City Planning Commission
Sacramento, CA

B. Special Permit Time Extension to allow 90 Unit townhouses on 11.2+ vacant acres in the R-1A (PUD) (LPPT-PUD) Zone (P-87-129).

LOCATION: North Side of Pocket Road between East Shore Drive and West Shore Drive

RE: P87-129
Parcel 22 at Riverlake

Partial Site Plan
 LOT 22 of Parcel 4 at Riverlake
 Scale 1"=30'

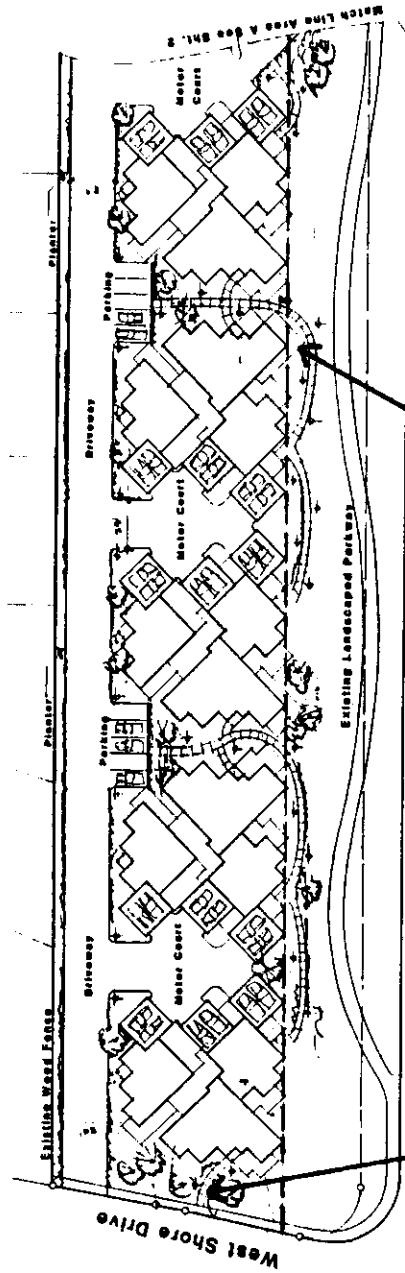
Several of the private patios for the residential units are indicated in the linear parkway (Exhibit C). These patio areas and any patio walls or fences must be located out of this required landscaped setback area.

Walkways are also indicated leading from residential units to the public right-of-way (East and West Shore Drives). Staff recommends that any private walkway crossing the linear parkway or a required landscaped setback and connecting a residential unit with the public right-of-way be prohibited as the walkway would encourage on-street parking.

Remove all patio areas from linear parkway (example)

Remove all private walks leading to public right-of-way from landscaped setback (example)

- a. All parking spaces, patios, patio walls and/or fences and walkways connecting the residential units with the public right-of-way shall be relocated outside of the linear parkway and any required landscape setback or eliminated from the site plan.

Partial Site Plan
 LOT 22 of Parcel 4 at Riverlake
 Scale 1"=30'

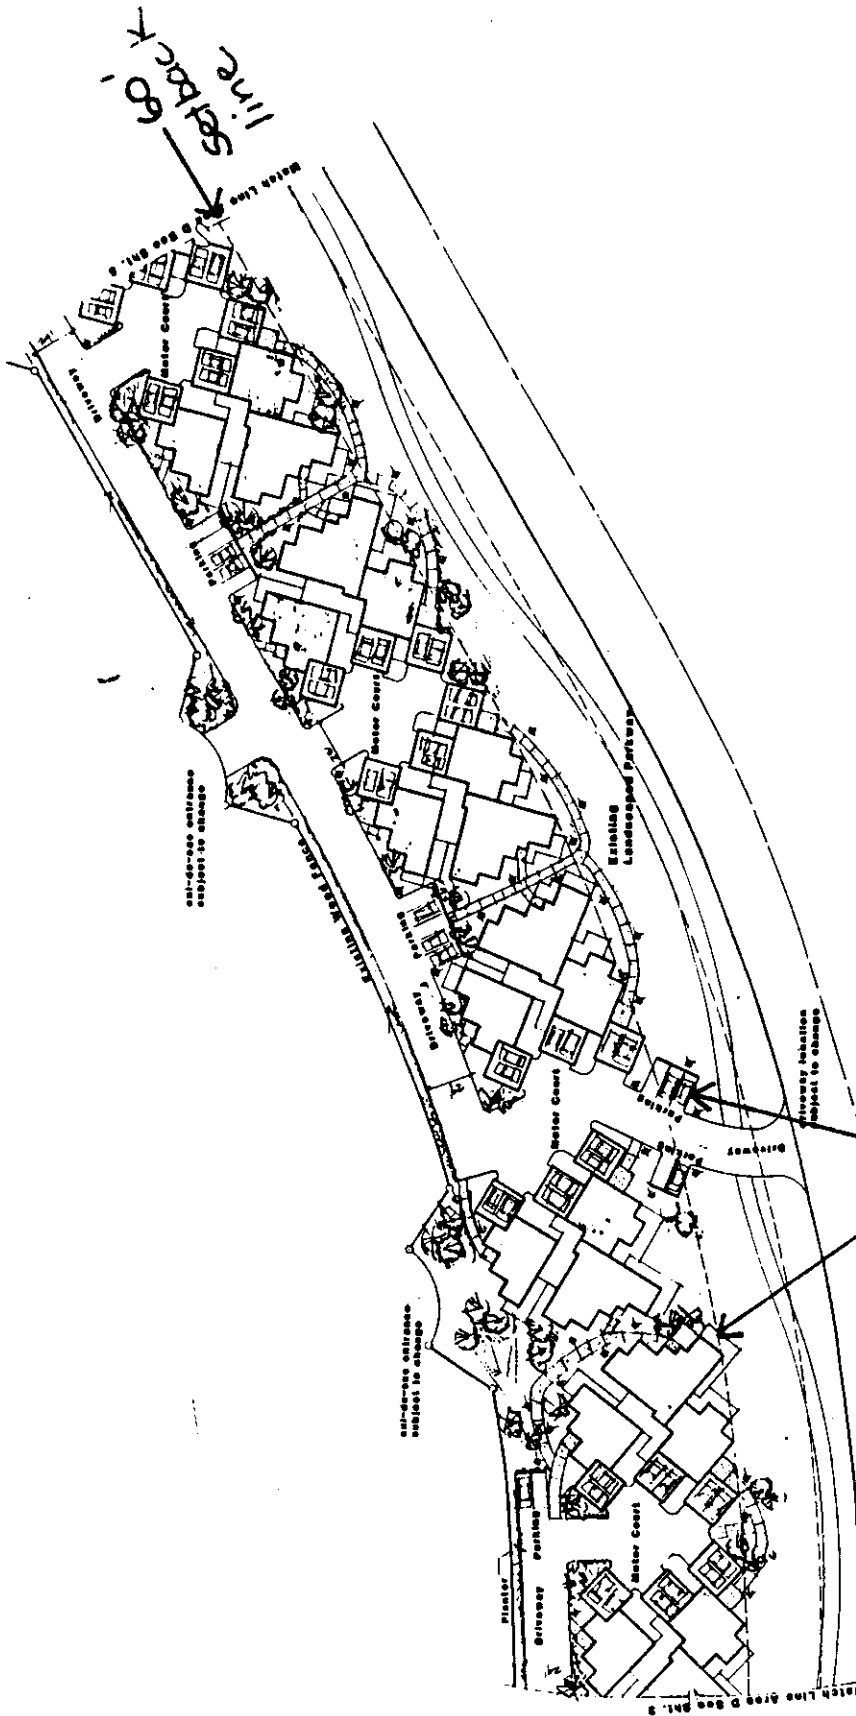
One-hundred-forty-one (141) parking spaces are required for the proposed development. The applicant is providing 90 two-car garages (180 spaces) and 79 guest parking spaces which exceed the minimum required. Sixteen of guest parking spaces are located in the linear parkway and two of the guest spaces do not meet City standards for maneuvering (Exhibit C). These 18 spaces will need to be relocated or removed.

Remove all parking and patio areas from linear parkway (example)
